**STATE SIGNIFICANT DEVELOPMENT ASSESSMENT:
Horsley Drive Business Park – Stage 2
Subdivision and Infrastructure Works
SSD 7664**

Environmental Assessment Report
Section 89H of the
Environmental Planning and Assessment Act 1979

November 2017

Figure 5: Proposed Site Access Road Intersection Layout

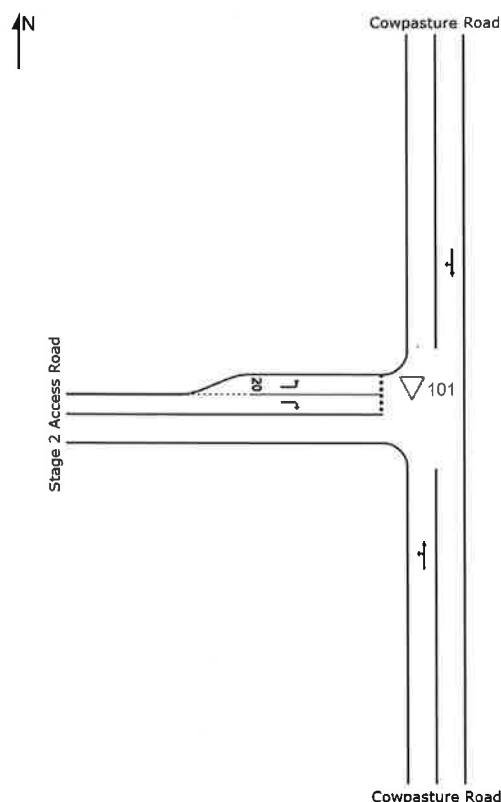
RMS initially recommended access to the site be moved to Trivet Street due to road safety and network efficiency. The Applicant later confirmed with RMS that the relocation of the access point to Trivet Street would not be physically viable given the difference in ground levels which would require significant earthworks to facilitate the construction of the access point.

Council requested the Applicant provide justification that the sight distance requirements for commercial vehicle traffic entering Cowpasture Road from the proposed site access driveway complies with Australian Standard AS 2890.2-2002. The Applicant clarified that the access road would have approximately 175 m visibility of southbound vehicles and 200 m visibility of northbound vehicles on Cowpasture Road. The access road line of sight would exceed the minimum requirements for a 60 km/h roadway of 83 m for a five second gap and 133 m for an eight second gap. Council accepted the location

of the access road and requested the Applicant provide a road safety audit prior to the commencement of works to verify safe manoeuvring into and out of the site.

Whilst RMS requested the road access to be from Trivet Street, the Department considers this location is impracticable given the steep topography of the site. The Applicant has demonstrated the lines of sight will exceed the minimum requirements for both north and south bound vehicles travelling along Cowpasture Road. The Department supports access to the site from Cowpasture Road on the basis safe access can be verified by the Applicant. The Department has recommended as a condition that the Applicant provide a road safety audit of the access road prior to the commencement of works to ensure that vehicles can safely manoeuvre into and out of the site from Cowpasture Road. The Applicant raised no objection to the recommended condition to provide a road safety audit.

Figure 7: Proposed Interim Intersection Configuration

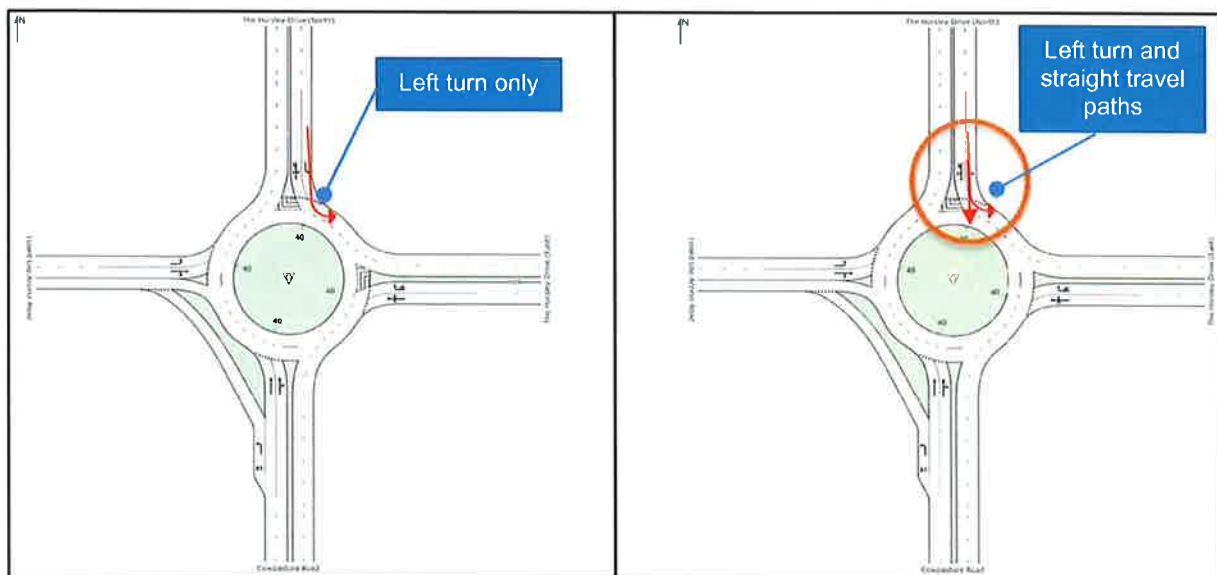
Recognising the poor performance of The Horsley Drive and Cowpasture Road roundabout intersection, the TIA recommended an interim upgrade to reconfigure the northern approach of the roundabout. The reconfigured approach would allow both lanes to continue south on Cowpasture Road (see **Figure 7**) rather than restricting this part to the inside lane. Modelling results indicated that the roundabout would operate at acceptable levels with the reconfigured northern approach.

RMS did not support the proposed intersection improvements on road safety grounds and requested the traffic modelling be amended for The Horsley Drive/Cowpasture Road roundabout intersection to show the existing traffic volumes and to provide further information in relation to the impact of queuing with the nearby signalised intersection on The Horsley Drive/Cowpasture Road.

Council raised concerns with the capacity of Cowpasture Road to accommodate operational traffic from the development. Council considers there would be a significant impact on the road network as the portion of Cowpasture Road between Victoria Street and Trivet Street is a collector road with one travel lane per direction and recommended the Applicant either reduce the scale of the development or undertake roadworks to increase the capacity of part of Cowpasture Road. Council also expressed concern that the traffic generation rates used in the TIA were not consistent with the RMS's guide to traffic generating developments updated traffic surveys 2013.

Both RMS and Council requested the remodeling of the baseline and forecasted traffic, and to review the revised model files (SIDRA).

The Applicant undertook further modelling and consultation with RMS and Council to address the concerns raised relating to traffic.

The Applicant provided further clarification that the traffic generation analysis provided in the TIA was based upon survey data from comparative developments including in Oakdale and Minto which best reflect the characteristics of the development. Council raised no further comment in relation to the traffic generation analysis.

Figure 10: Acoustic barrier on Lot 4

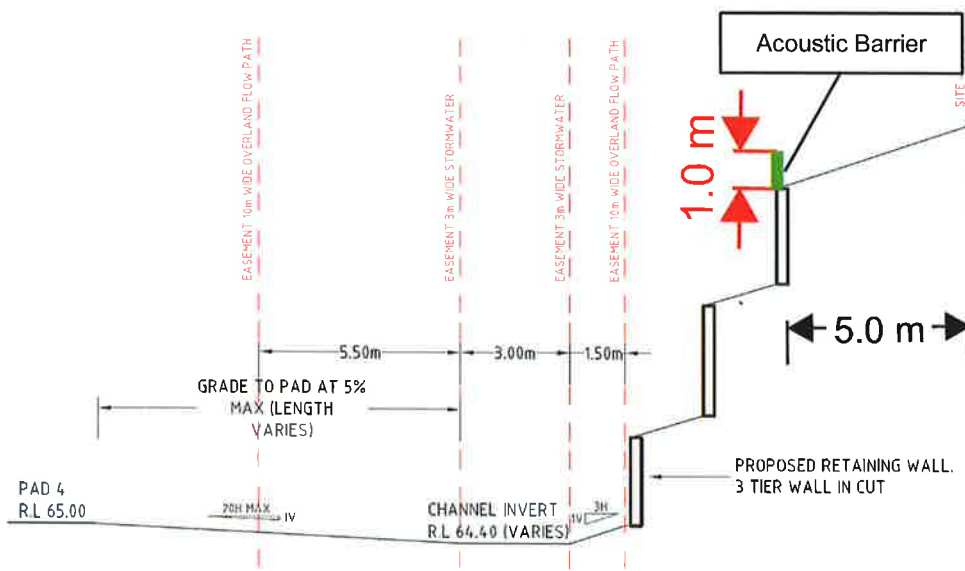
The Department notes there may be a period when the proposed development is operational, prior to the dedication of the internal access road to the relevant roads authority. During this period, the INP would apply to traffic noise generated within the site and there is potential for operational noise levels to exceed the night-time intrusiveness criteria at Location A without any mitigating measures (such as the installation of an acoustic barrier).

The acoustic modelling results indicate that the acoustic barrier would reduce the predicted noise levels by 3 dB during the evening and night-time period. The Applicant provided a drawing of the acoustic barrier to show that the barrier would not be visible from Trivet Street due to the slope of the land and would be setback from the property boundary (see **Figure 10**).

The Department recommends the installation of the acoustic barrier as a mitigating noise measure to enable the Applicant to achieve noise limits. The acoustic barrier is considered acceptable due to the following:

- it will be wholly contained within the site and will be maintained by the developer/tenant;
- it will not be visible from Trivet Street due to the low height of the barrier and slope of the land; and
- it will provide an additional level of safety to the retaining walls on Lot 4.

The Department has recommended conditions around the maintenance and design of an acoustic barrier to ensure any barrier is integrated with the proposed landscaping on the site and maintains the amenity of Trivet Street. The Department has also recommended the Applicant screen any acoustic barrier with a mix of shrub planting and trees. Detailed noise assessments will also be required as part of future DAs to ensure operations achieve compliance with the operational noise limits.
